AGENDA

STATE BUILDING CODE TECHNICAL REVIEW BOARD

Tuesday, May 20, 2016 - 10:00 a.m.

# RESIDENTIAL BELOW GRADE DRAINAGE DETAIL (NON-SEVERE GROUNDWATER TABLE) NOT TO SCALE

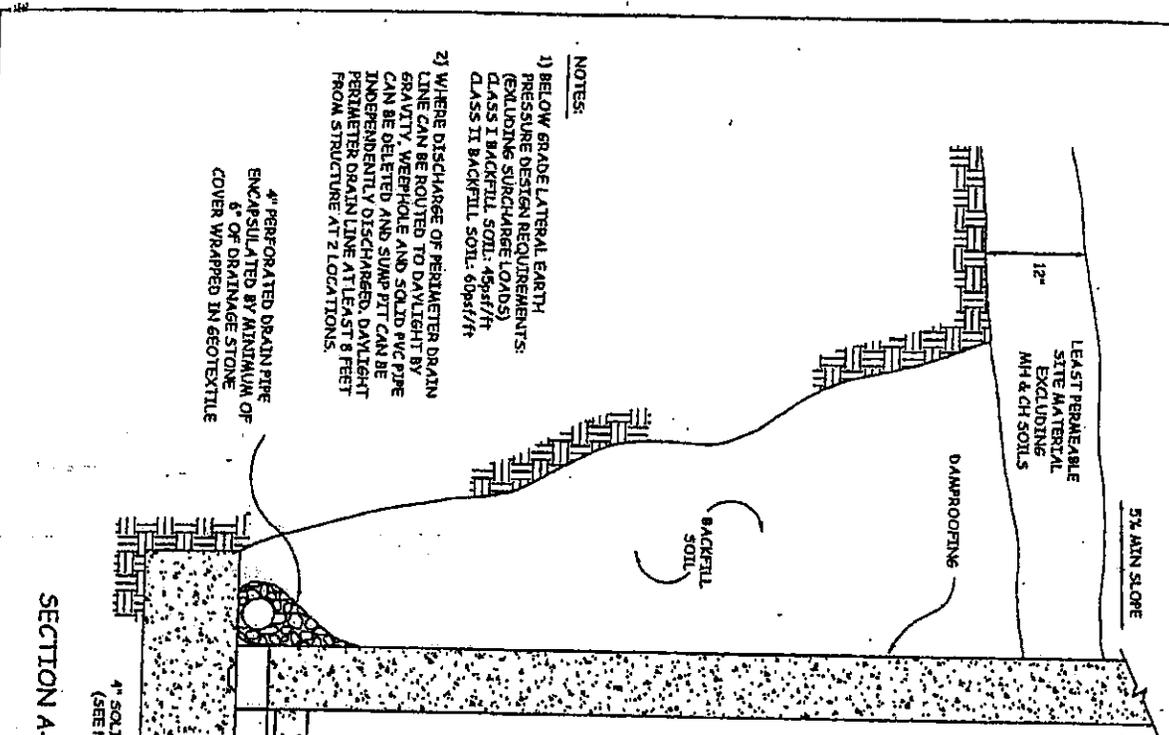
I think this is what you were looking for. Pls. let me know if this is ok or if you need anything else. Pls. read the text from Mr. Andonyadis from ECS to further understand where they got this detail from.

When those reports were issued back in 2001 there was no detail included, however we looked at similar reports issued for other projects in Broadlands area that we did at that time and we believe that the attached detail is applicable.

The page you sent to me was included in the report that was originally requested by Loudoun County. The information that I am requesting is from page 17 of the report (ECS Job No. 5587-G1) at the last sentence of the third paragraph. It reads as follows. "A Residential Below Grade Drainage Detail is enclosed in the Appendix which depicts our recommendations concerning acceptable below grade wall backfill types, design lateral earth pressures and below grade drainage. I appreciate your help with this matter and I can be reached at (703) 771-5751.

### FOUNDATION PLAN SCHEMATIC

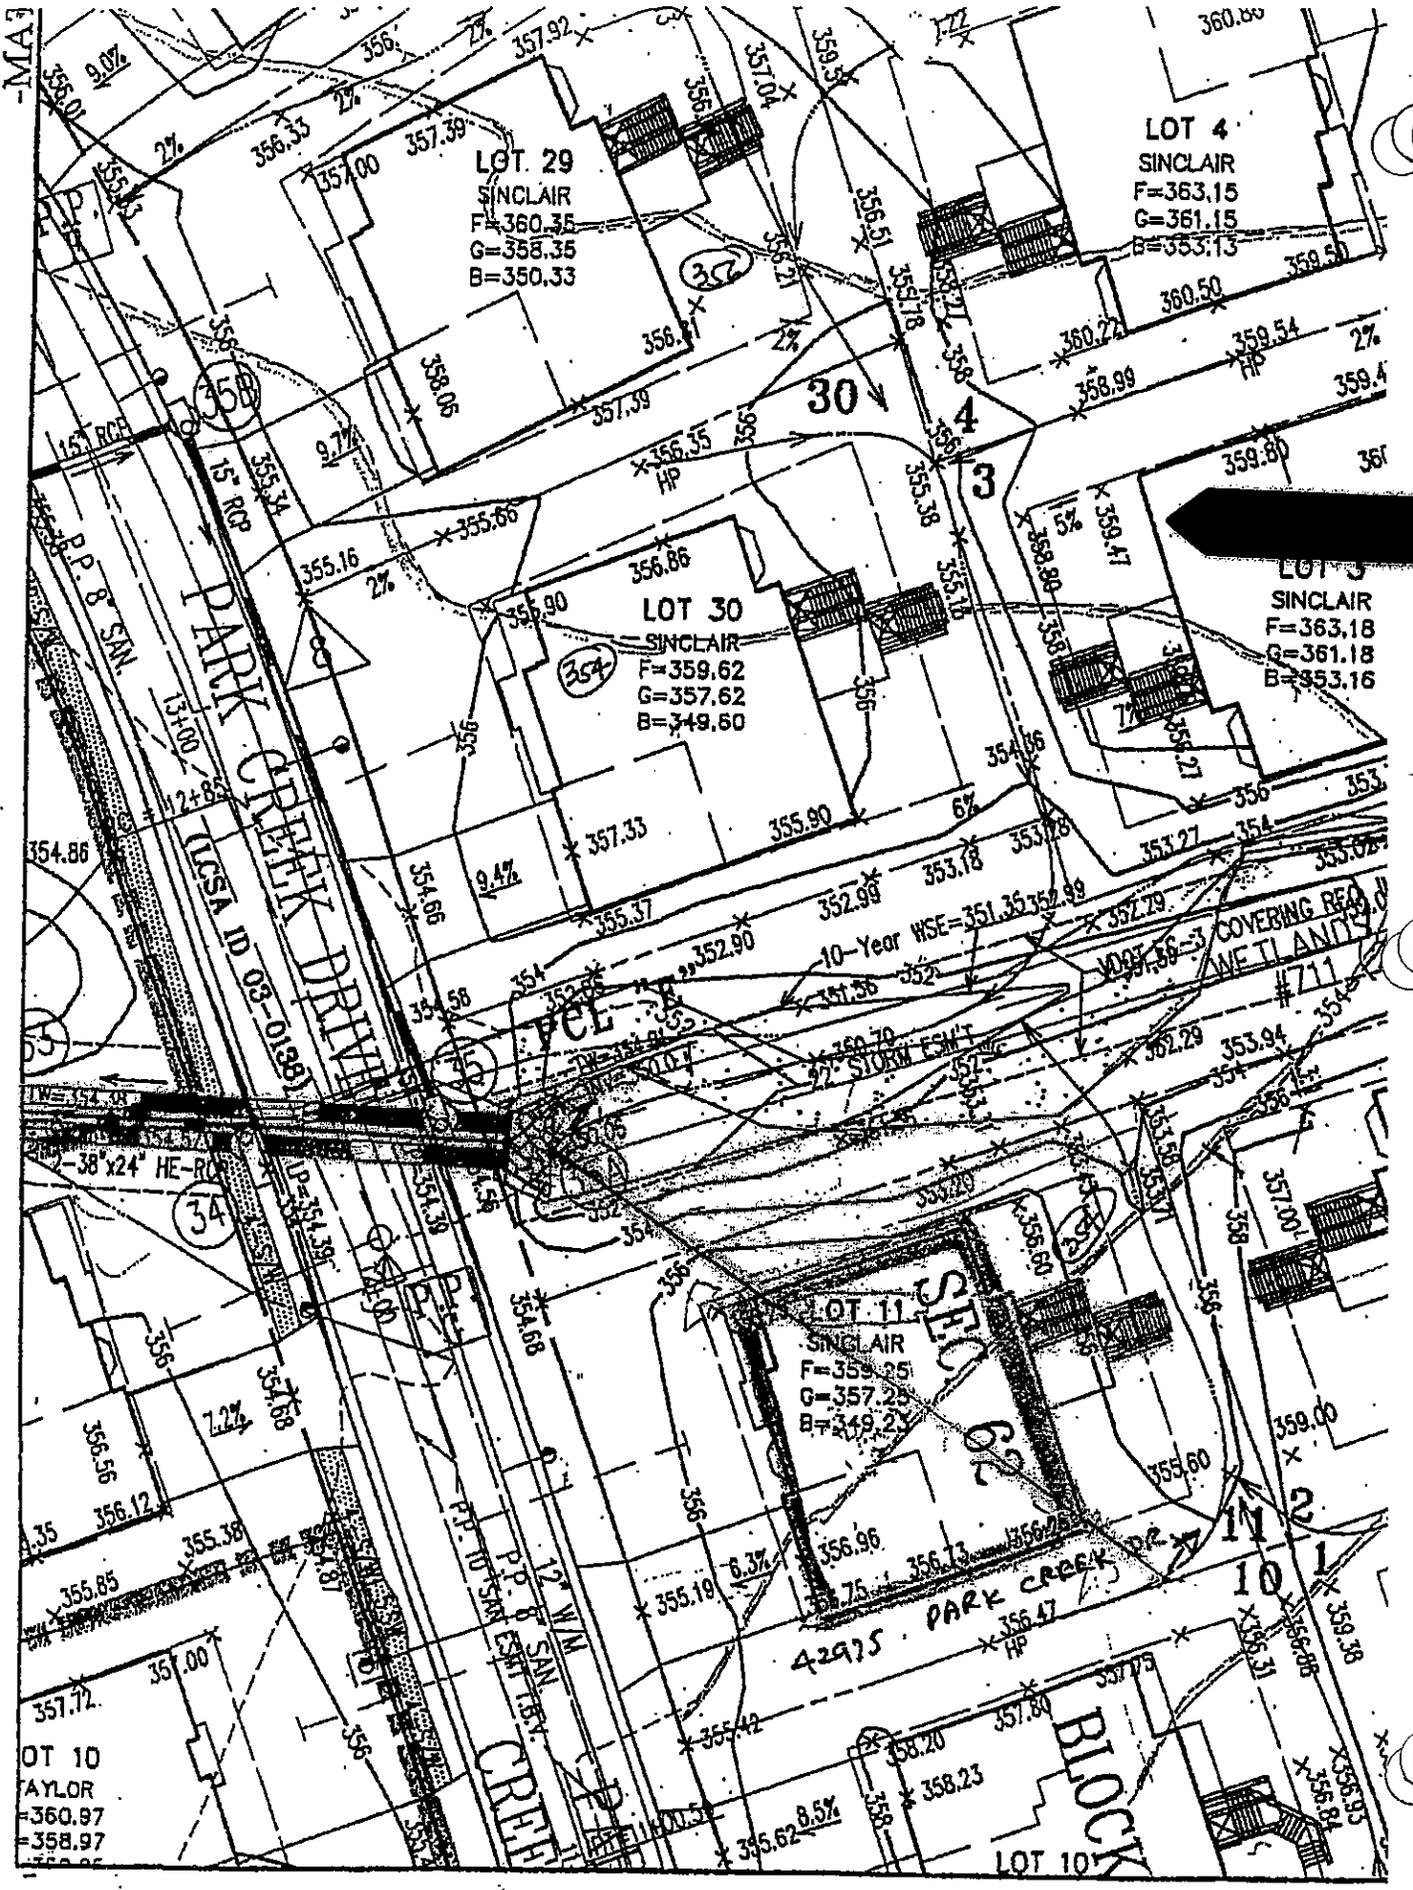
The sump pump is one of the components of the water drainage system for the Home. The Home also has a foundation drainage system. Enclosed is a copy of the plan for the foundation drainage system, which was approved by Loudoun County. Loudoun County also inspected and certified as completed the foundation drainage system before the certificate of occupancy for the Home was issued. To date, the water drainage system is operating as designed, water is draining through the foundation drainage pipes into the sump pump crock, and the sump pump is discharging the collected water away from the Home's foundation. Earlier this year, Van Metre Homes customer care personnel visited the Home to inspect the foundation drainage system. The personnel confirmed that ground water was entering the sump pump crock both through the foundation drainage pipes and otherwise by the proper direction of water per the underground portion of the foundation drainage system.
